# Access Compliance Report

## Public Rights-of-Way

Intersection ID: 13388	Main Street: S_CHURCH_ST	Cross Street: W_SUMMIT_AV	Location: SE
ADA ID: B55E369B1A23	Ramp Type: Perp	Initial Pass/Fail: Pass	Overall Compliance: No
			Severity Score: 2.5

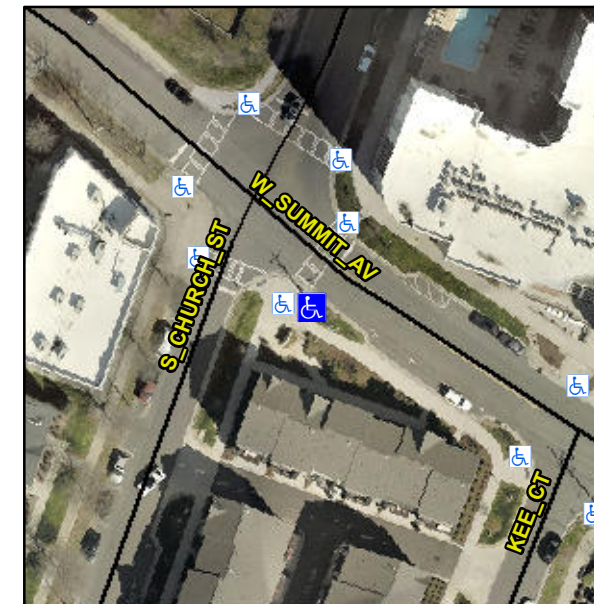
**R304.2.3, R305.2**

Compliance	Description	Data	Compliance	Description	Data
N/A	Ramp Length (in)	114.0	Yes	Ramp Slope (%)	6.8
Yes	Ramp Width (in)	54.0	Yes	Ramp XSlope (%)	0.8
N/A	Flare Type LT	Sloped	N/A	Flare Type RT	N/A
N/A	Flare Slope LT (%)	6.1	No	Flare Slope RT (%)	10.3
N/A	Flare Traversable LT?	Yes	N/A	Flare Traversable RT?	Yes
Yes	Landing Length (in)	48.0	Yes	DWS Provided?	Yes
Yes	Landing Width (in)	52.0	Yes	DWS Contrast?	Yes
Yes	Landing Slope (%)	0.7	Yes	DWS Length (in)	24.0
Yes	Landing X Slope (%)	1.1	Yes	DWS Full Width?	Yes
N/A	Landing Curb? (Y/N)	No	No	DWS Offset (in)	6.0
N/A	Shared Landing?	No			
Yes	Gutter Ponding?	No	Yes	Gutter Slope (%)	4.1
Yes	Gutter Lip Ht (in)	0.0	Yes	Gutter X Slope (%)	1.1
N/A	Painted X Walk1?	No	N/A	Painted X Walk2?	N/A
	X Walk 1 Direction	To NE		X Walk 2 Direction	N/A
N/A	X Walk 1 Width (in)	N/A	N/A	X Walk 2 Width (in)	N/A
	X Walk 1 Slope (%)	0.8		X Walk 2 Slope (%)	N/A
	X Walk 1 X Slope (%)	3.8		X Walk 2 X Slope (%)	N/A

**Remove & Replace Entire Ramp.**
